NATIONAL CAPITAL DESIGN REVIEW PANEL

Block 9 Section 132 Casey – First Session
Sky Terrace

THE PANEL'S ADVICE

| Date issued: | 5 July 2022 | |

Typical Floor Plan

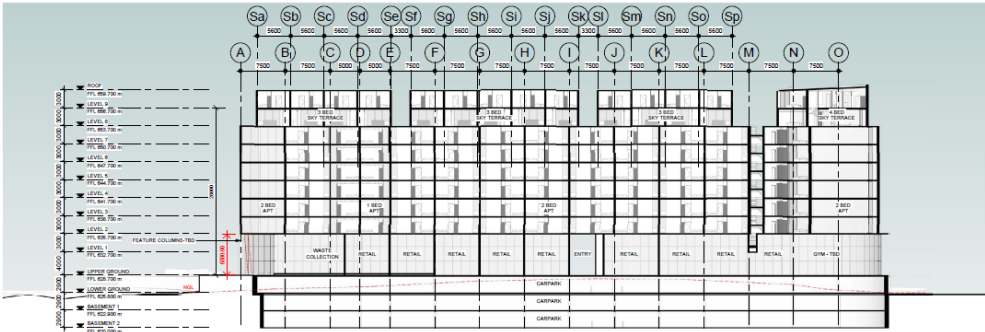
- 4.2 While the proponent's intention to provide an efficient scheme that includes pleasant journeys to each dwelling entry is acknowledged, the Panel considers that the current arrangement including the central skybridge has served to compromise solar access to the atrium and has may give rise to overlooking issues. The proponent is encouraged to explore incorporation of multiple cores to allow for an open atrium and to allow a proportion of dwellings to achieve full depth. The Panel also observes that an alternative core arrangement may also facilitate improved landscaping within the atrium, including potential for connected deep soil zones to support an enduring landscape for the proposal.

- 4.3 In relation to the central courtyard, the Panel is concerned that this presents as under-scaled relative to the vertical scale of the proposal. The Panel is also concerned that the space may not yield a high-quality, healthy landscape owing to the absence of demonstrated deep soil zones and low levels of solar access. In addition to the recommendation for a reconfiguration of the core(s) and external accessways (see 4.2) the Panel encourages the proponent to explore provision of deep soil zones within the courtyard that are connected to natural systems, as well as other means to increase solar access to this space to support residential amenity and a healthy landscape.

- 4.4 The Panel considers that issues of potential visual and acoustic privacy to the second bedroom adjacent to the walkway have not yet been demonstrably resolved and encourages the proponent to refine the design to address these concerns.

Landscape Plan (lower level adaptable commercial redacted by Secretariat)

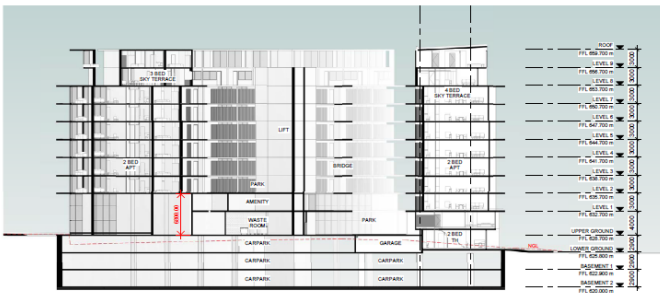
- 2.1 The Panel notes that the proposal as presented has not demonstrated a positive contribution to the ACT Government's aspirations for tree canopy and permeable surfaces in response to the potential for urban heat and anticipated climate change risks. The Panel is generally not supportive of proposals that do not address their social and environmental responsibility to provide canopy cover and therefore seeks clarity and certainty about the proponent's intentions in this regard and encourages further incorporation of meaningful landscape within the site area (e.g. green roofs, use of permeable materials, deep soil zones).
-
